PRODUCT CHANGE NOTICE PCN Form (D4-E000-73)

PCN#18-021

Existing Model:	Replacement Model:
ROS-3150+	ROS-3150R+
ZX95-3150-S+	No change in p/n

ATTACHMENTS:

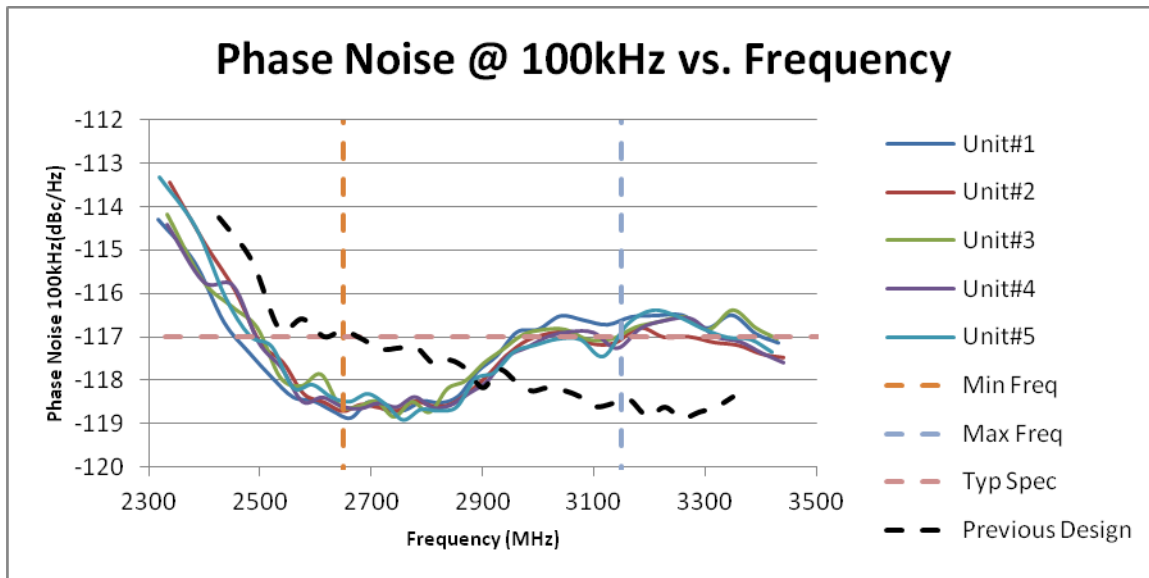
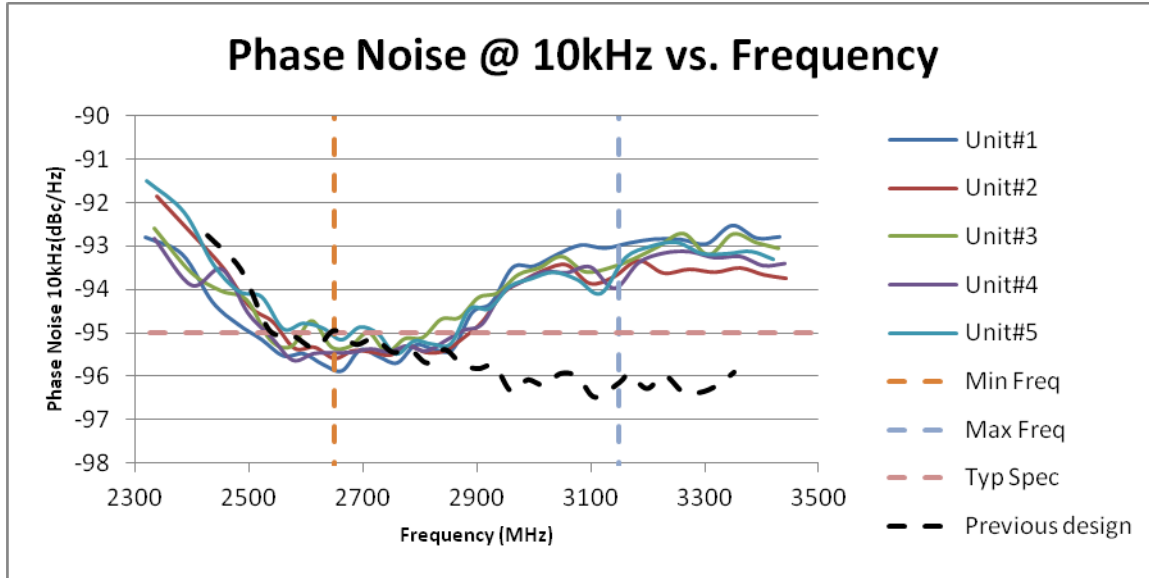
Parameters	Original Performance	Original spec	New Performance	New Spec
Power Out	5.98 to 6.39 dBm	6.2 dBm Typ	4.54 to 5.31 dBm	5 dBm Typ
Sensitivity	57.4 to 68.8 MHz/V	64 - 75 MHz/V Typ	63.1 to 90.6 MHz/V	63 - 90 MHz/V Typ
DC Current	35 to 35.3 mA	42 mA Max	35.8 to 37.9 mA	45 mA Max
Ph. N	No significant change in values, phase noise characteristic changed, see graphs below
